RE: **Lot 3 Block 10 Unit 5 SAD 227**
Volcano Cliffs
8001 Marigold Rd. NW
Grading and Drainage Plan
Engineers Stamp Date 3/26/2021 (E10D104)
Pad Certification Date 5/27/2021

DRAINAGE AND TRANSPORTATION INFORMATION SHEET (REV 6/2018)

ENGINEER'S SEAL	8001 MARIGOLD	DRAWN BY WCWJ
	GRADED AND DRAINAGE PLAN	DATE 3-24-21 210210033-LAYOUT-3-24-21
3/26/21		SHEET # —
DAVID SOULE P.E. #14522	Rio Grande Engineering 1606 CENTRAL AVENUE SE SUITE 201 ALBUQUERQUE, NM 87106 (505) 872-0999	JOB # 210210033

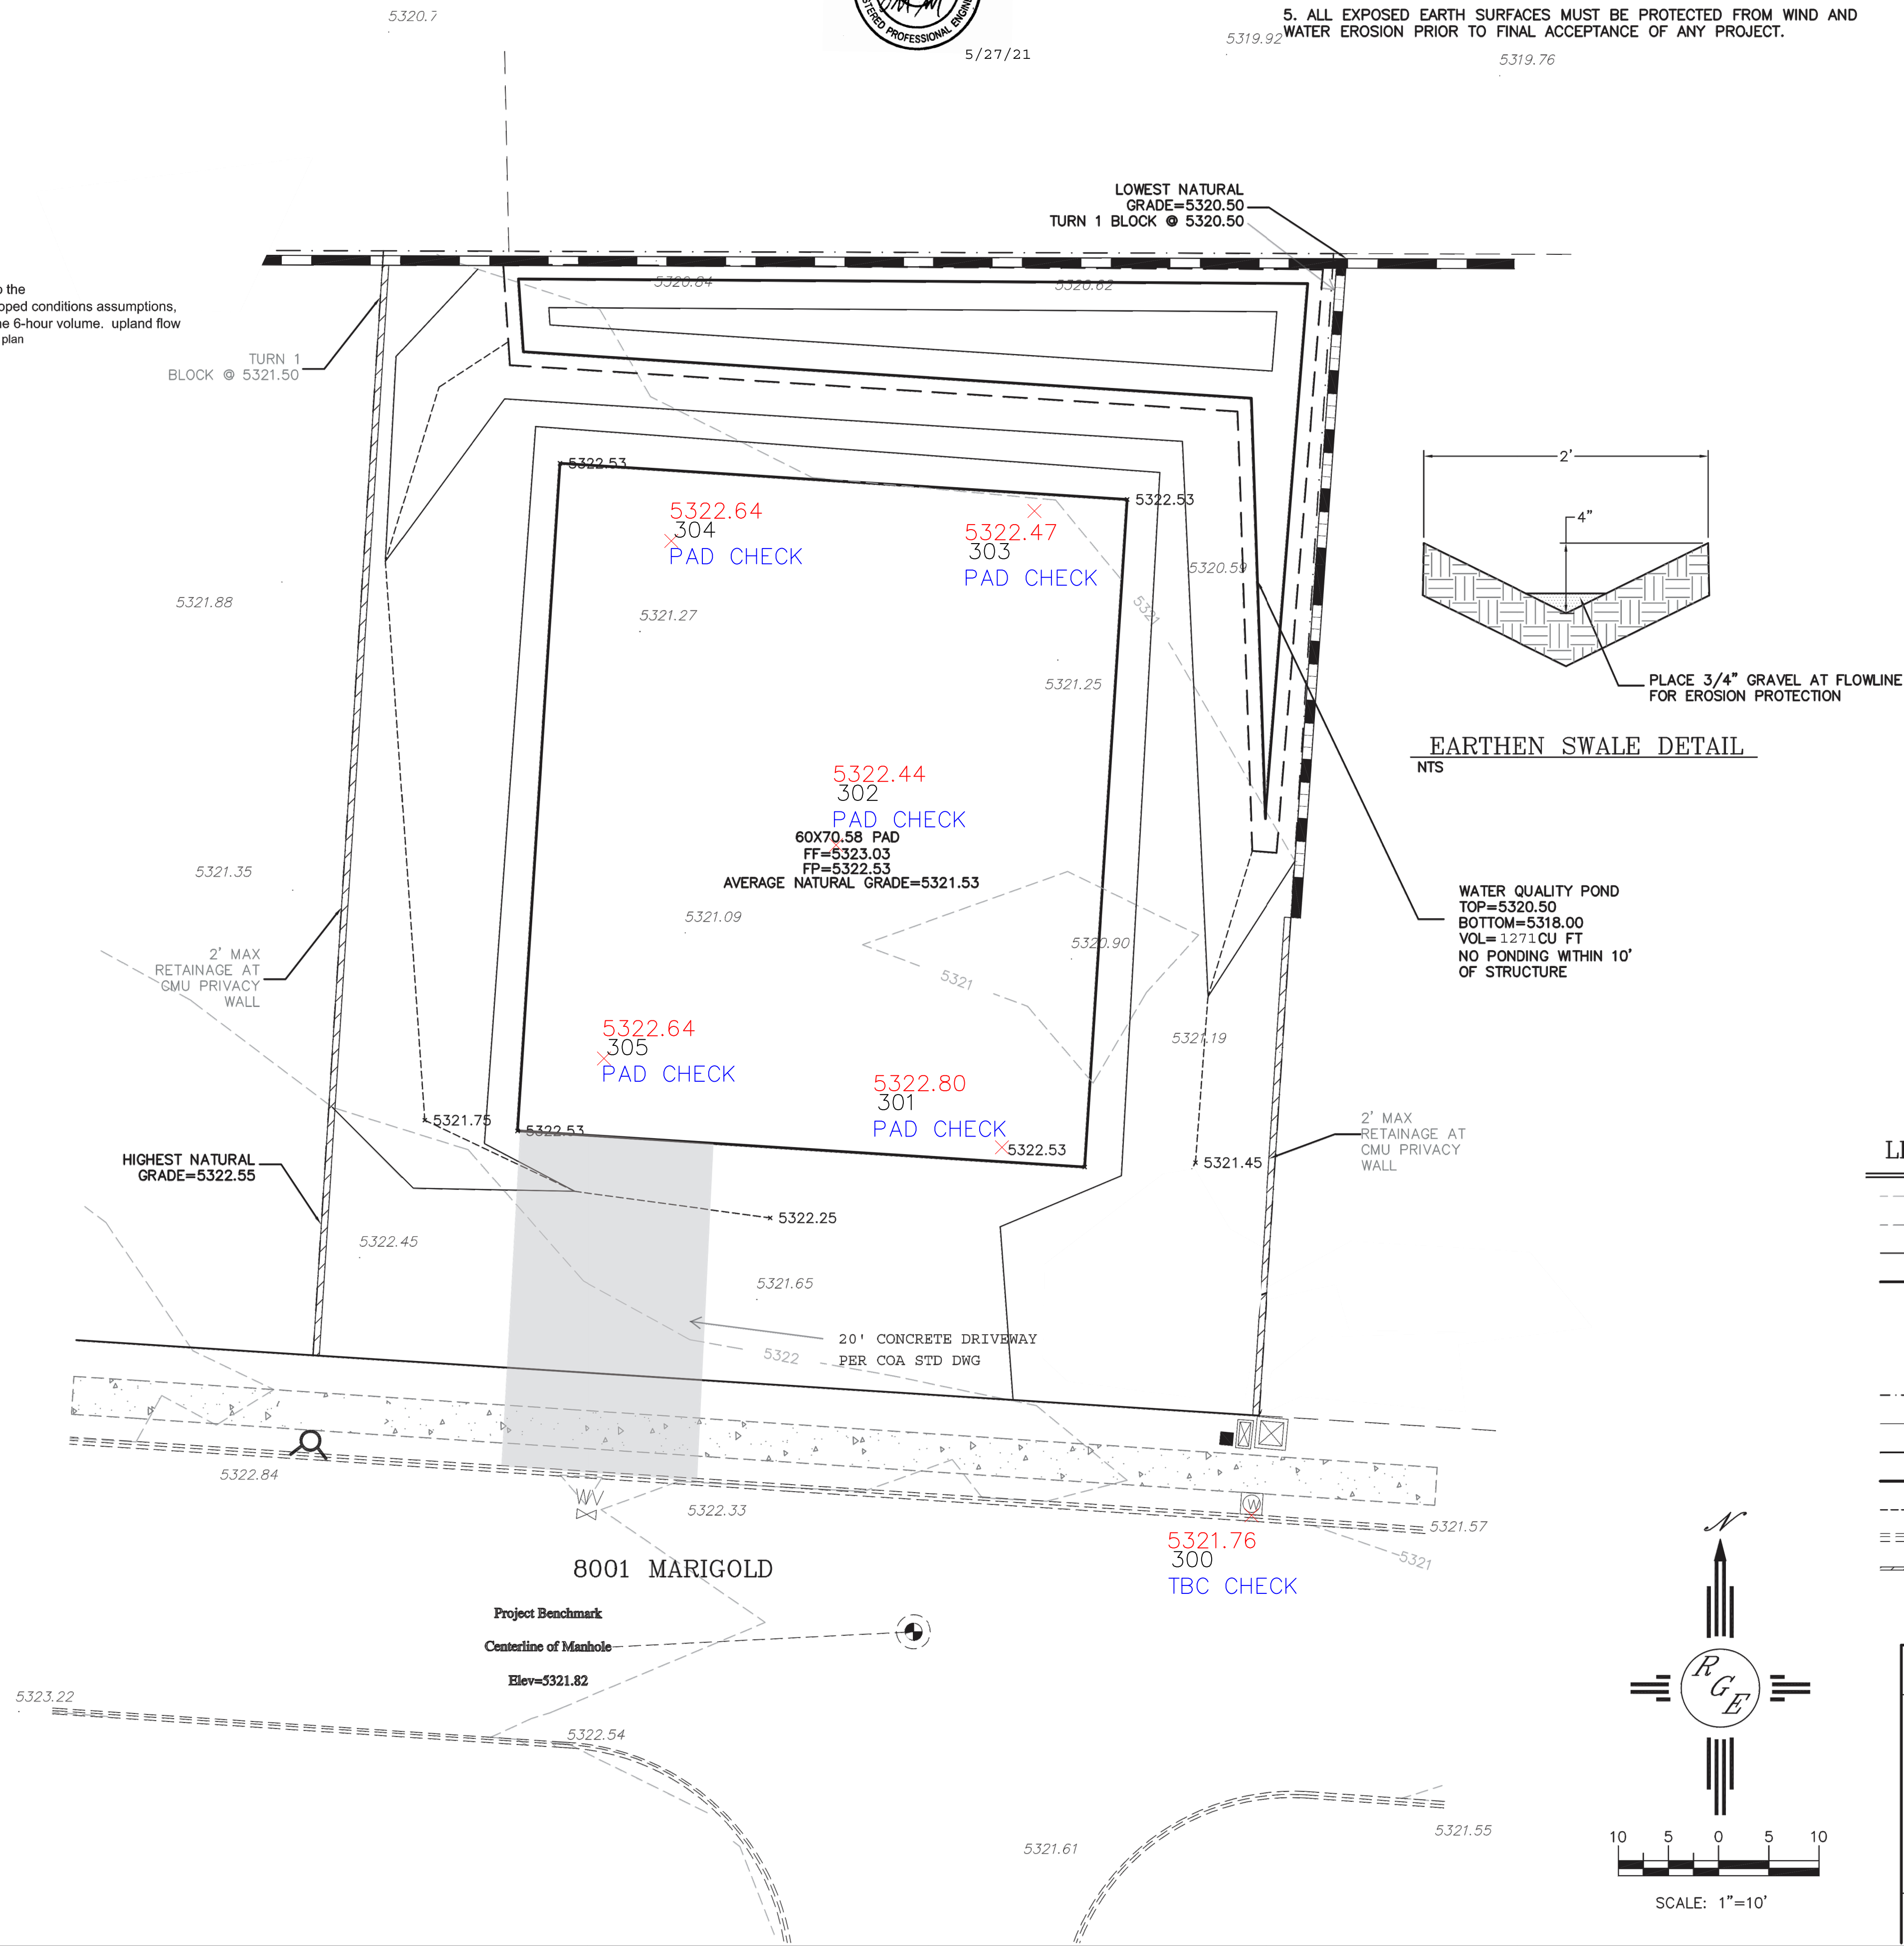
Based upon the information provided in your submittal received 5/27/2021, this plan is approved for Building Permit.

Reiterate to the Owner/Contractor that a separate permit for a garden/retaining wall must be obtained, with the approved G&D plan. Also, advise the owner/contractor not to use dirt as a ramp to climb the curb. If dirt is used it will cause a delay in permitting.

Prior to Certificate of Occupancy release, Engineer Certification per the DPM checklist of this plan will be required.
